RESPONSE TO RAI #1 GAS COLLECTION AND CONTROL SYSTEM CONSTRUCTION CERTIFICATION

SOUTHEAST COUNTY LANDFILL HILLSBOROUGH COUNTY, FLORIDA

Subject: Response to Request for Additional Information (RAI) No. 1
Gas Collection and Control System Construction Certification
Southeast County Landfill, Hillsborough County, Florida
Permit No. 35435-016-SC/08
WACS No. SWD/29/41193

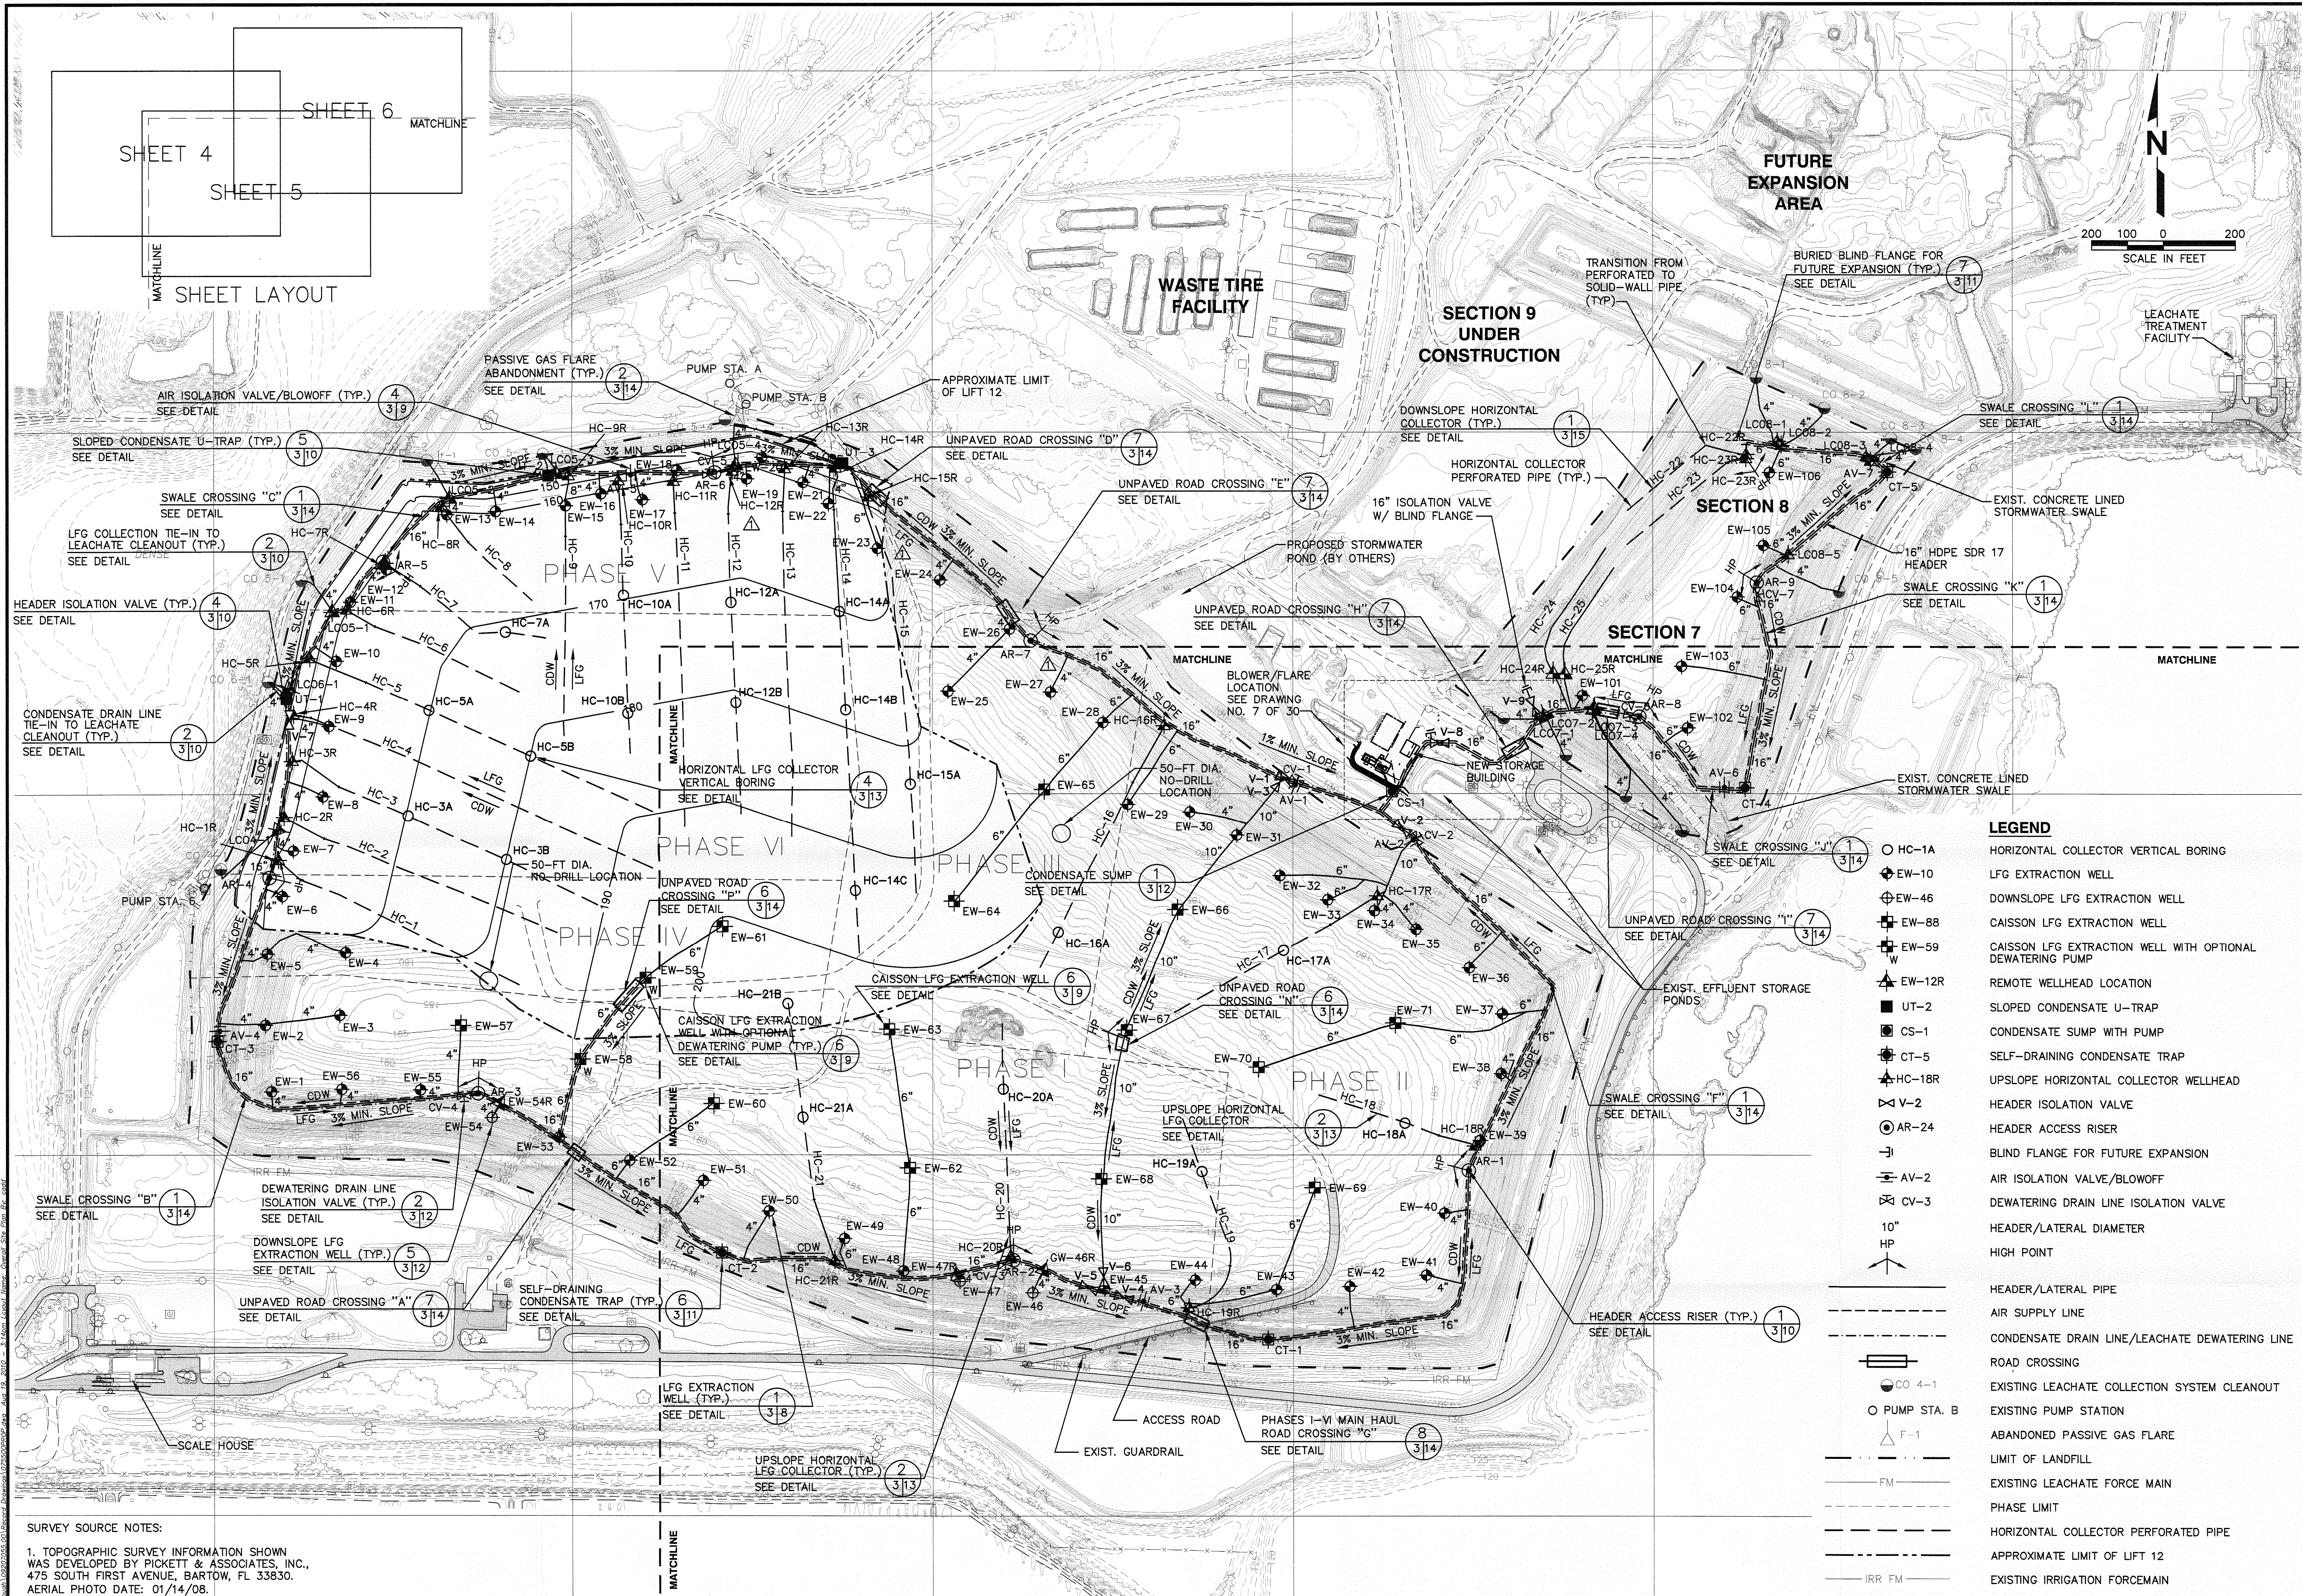
a. The installation of the air supply lines and dewatering force main at EW-59 referenced in this section and shown on Sheet 3 of 30 of the Record Drawings is a deviation from the plans and application approved by the Department in Permit No.

35435-016-SC/08. Department records do not appear to indicate that a permit modification was applied for and issued by the Department for this construction modification or that this construction modification was otherwise approved by the Department in accordance with Specific Condition #A.3.a. of Permit No. 35435-016-SC/08. This appears to constitute a violation of Rule 62-701.320(1), F.A.C. Please verify and explain.

b. An as-built detail or detail reference for modified EW-59 does not appear to be provided in the Record Drawings. Please verify and revise the Record Drawings, as appropriate.

Response: Attachment 2 of this response contains a revised Report of Construction with the information further describing the Dual Gas Extraction/Leachate Dewatering Wells, which are also known as Extraction Wells with Optional Dewatering Pump.

Response: Detail 6 on Sheet 9 of the Record Drawings, in conjunction with Detail 5 on Sheet 9 (as referenced in Detail 6), provides the as-built detail for the construction at EW-58 and EW-59. Attachment 3 contains a revised Record Drawing Sheet 3 of 30 that includes the appropriate reference to Detail 6 on Sheet 9 for EW-58 and EW-59. At this time the dewatering pump, modified wellhead assembly, valves and regulator have yet to be installed, however the wells have been selected for the optional configuration should the need for the pump arise.

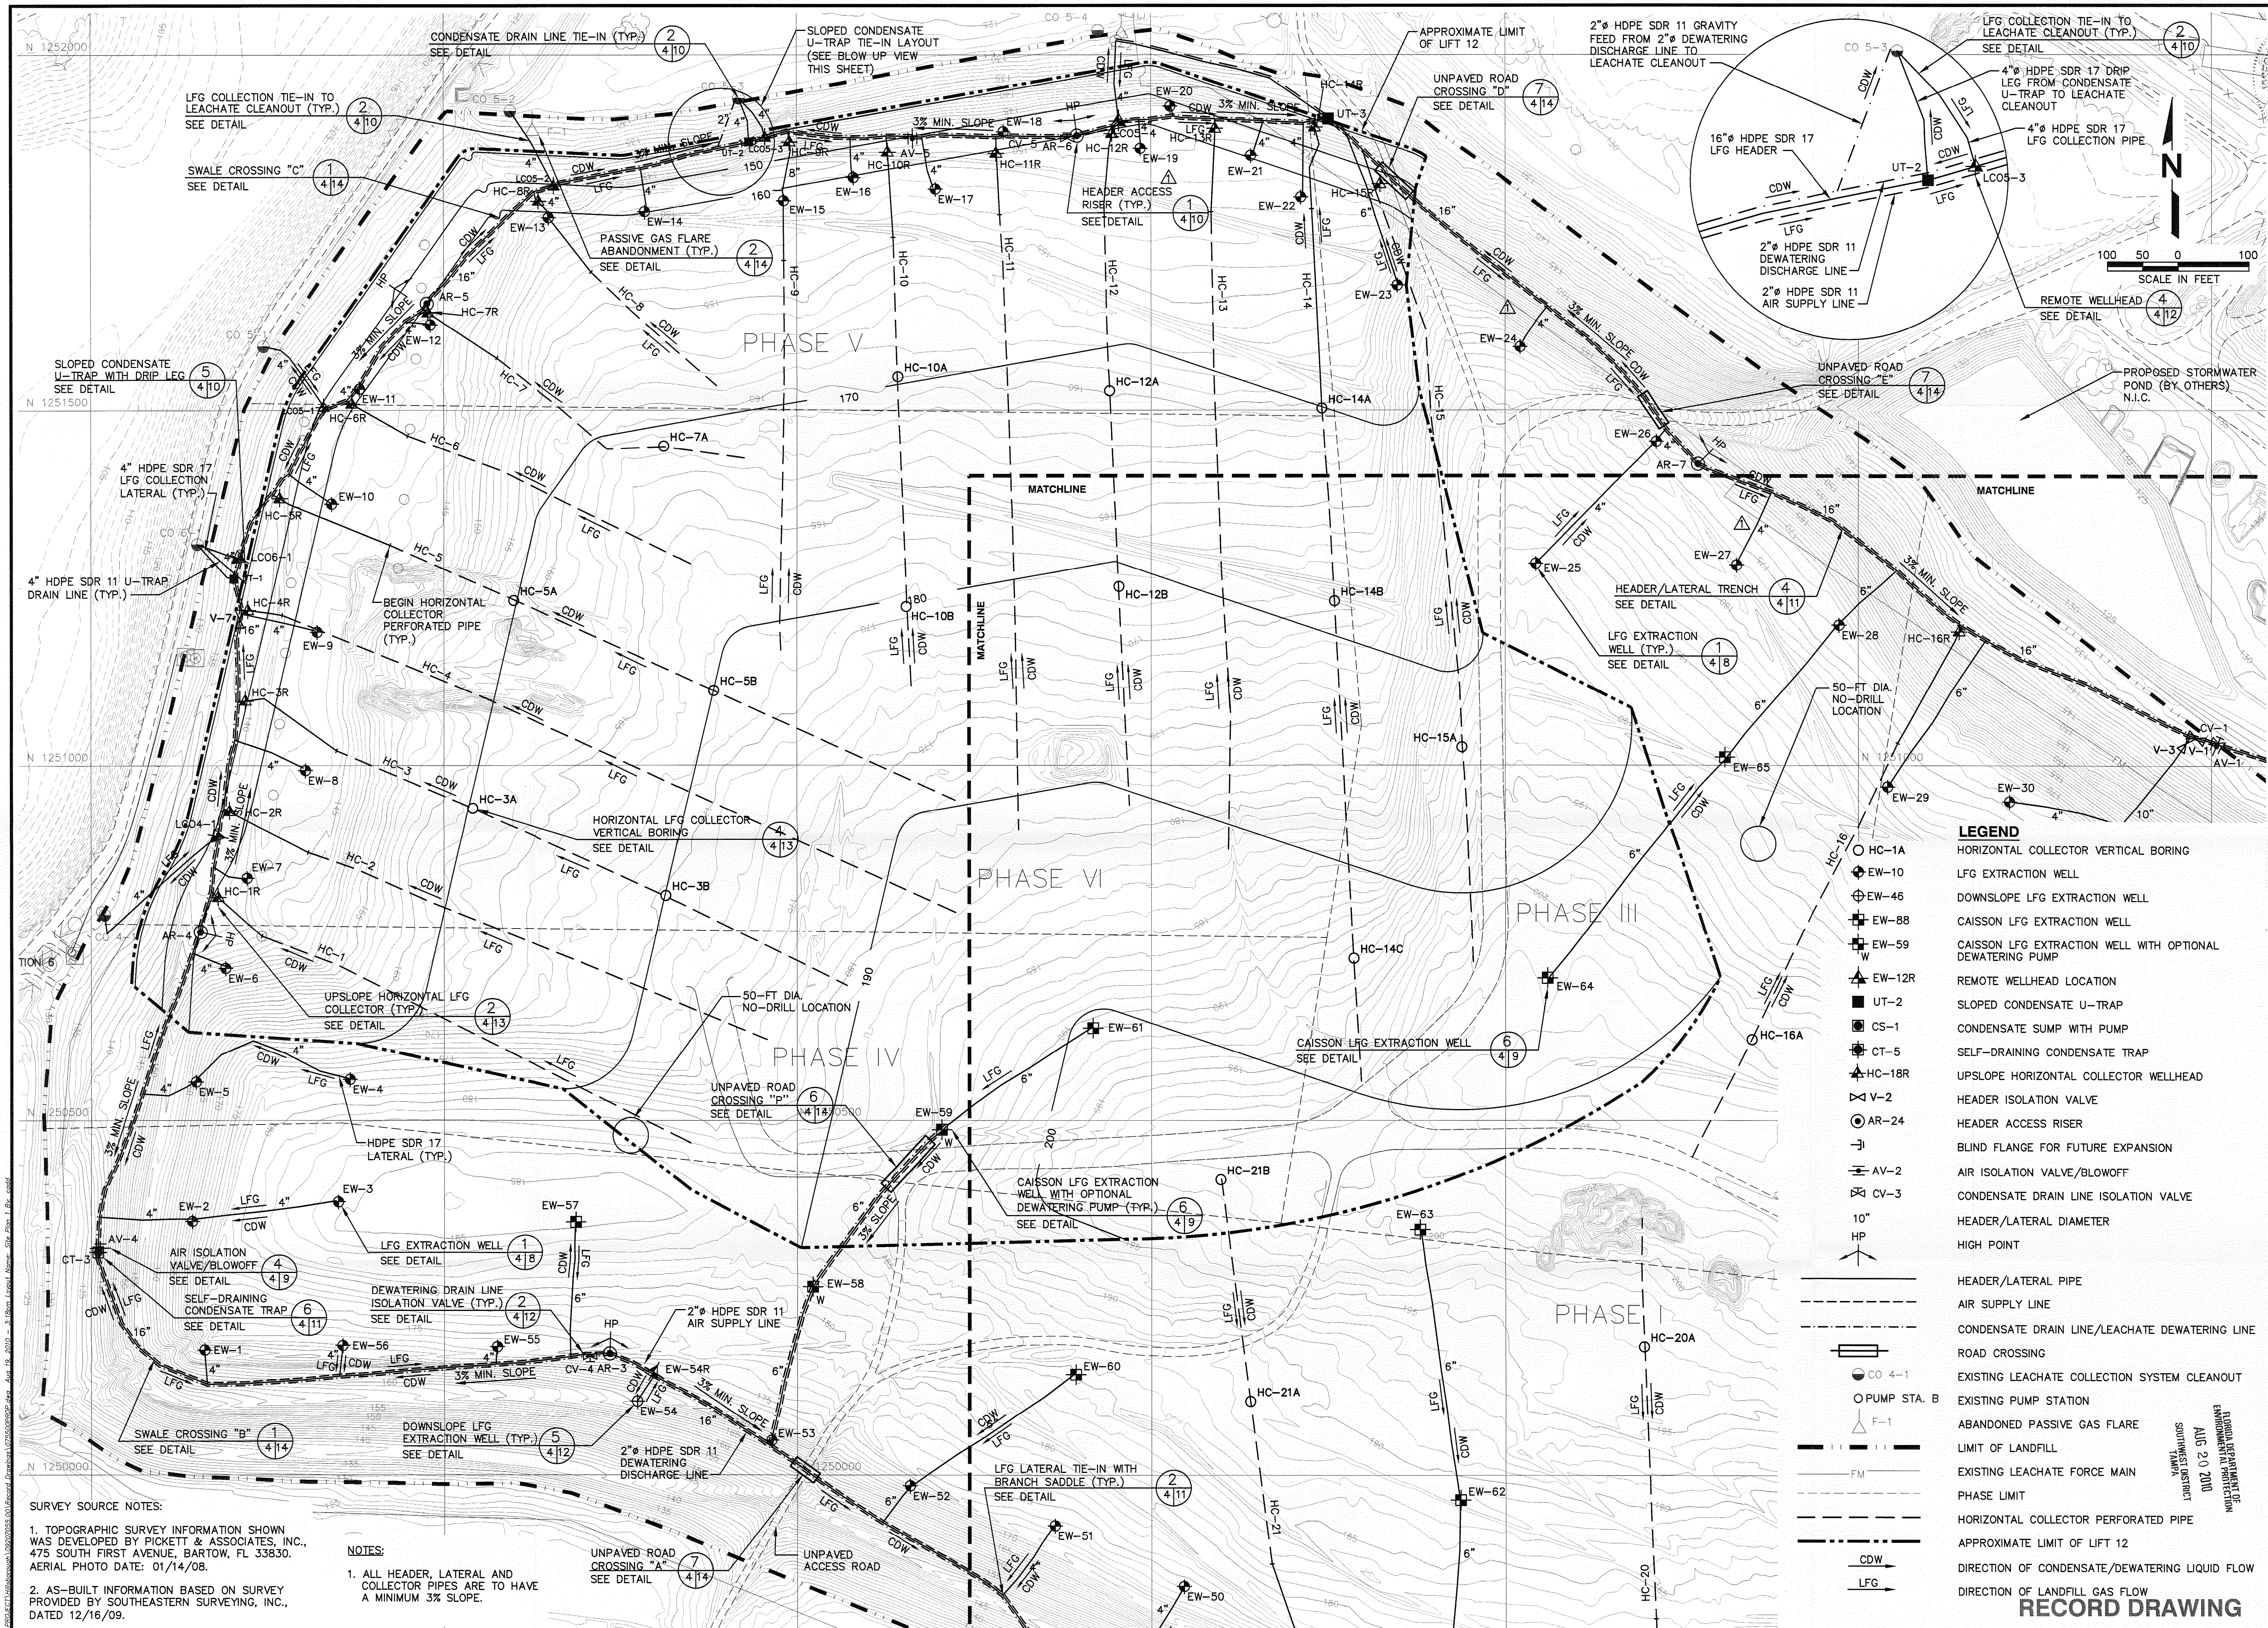
6. **Sheet 4 of 30: Please explain the change in location and configuration between CO 5-3, UT-2, and LCO 5-3 (See Comment #1.a).**

Response: Attachment 3 of this response contains revised Sheets 3 and 4 of the Record Drawings that have been corrected and more clearly indicate the operation of the UT-2, as well as the other traps. Sheet 10 of 30 has also been updated with a more detailed cleanout tie-in schedule to clarify the system operations. The traps were installed correctly and are functioning as designed. The exact location of these lines was modified in the field to accommodate landfill topography and the location of the low points in the header and condensate lines as constructed. To further explain what is happening at this and several other low points where UT traps are utilized, each line will be explained separately. As shown in Detail 2 on sheet 10 of 30, there are potentially three lines that connect to a leachate cleanout that can be utilized for both leachate deposit and the removal of landfill gas (LFG). Below is an explanation of each line.

First: The 2-inch dewatering/condensate line that runs next to the header and receives liquids from pumps installed around the landfill will gravity feed condensate into the leachate cleanout. The connection is a 2-inch HDPE pipe that is connected from near the low point in the 2-inch condensate line into the leachate clean out. The connection does not have to be exactly at the low point since gravity will ultimately push the liquid into the cleanout once accumulation reaches the level of the connection. This line is indicated by a dashed line with a dot in between dashes on the blow up on Sheet 4 and in the legend on the plans.

Second: The 4-inch HDPE pipe from the drip leg of a U-Trap, as shown in Detail 5 on Sheet 10 of 30 and blow up on Sheet 4, delivers condensate from the main landfill gas header to the leachate cleanout. This 4-inch HDPE drip leg pipe comes out the bottom of the U-Trap (which is located at the low point in the header line) and gravity feeds into the leachate cleanout after the vacuum break. This allows for condensate to be removed from the header line without a break in header vacuum or utilization of a pump. These 4-inch lines are indicated by a solid line on the plans with 4-inch label.

Third: The 4-inch HDPE gas collection line extracts LFG from the leachate cleanouts. This pipe runs from the cleanout to the header line where a remote wellhead is placed to control the vacuum being exerted on the cleanout. The 4-inch line from the header to the cleanout does not have to be a low point on the header line but does need to slope from the header line to the cleanout so that condensate from the LFG in this pipe can also drain

back into the cleanout. This line is indicated by a solid line with 4-inch label which runs to a remote wellhead indicated by a remote wellhead symbol where the wellhead is connected to a header riser.

Three connections are the most any cleanout will ever have and most will have just the 4-inch connection to remove LFG as needed. The cleanout tie-in schedule on Sheet 10 further outlines the tie-ins at each cleanout.
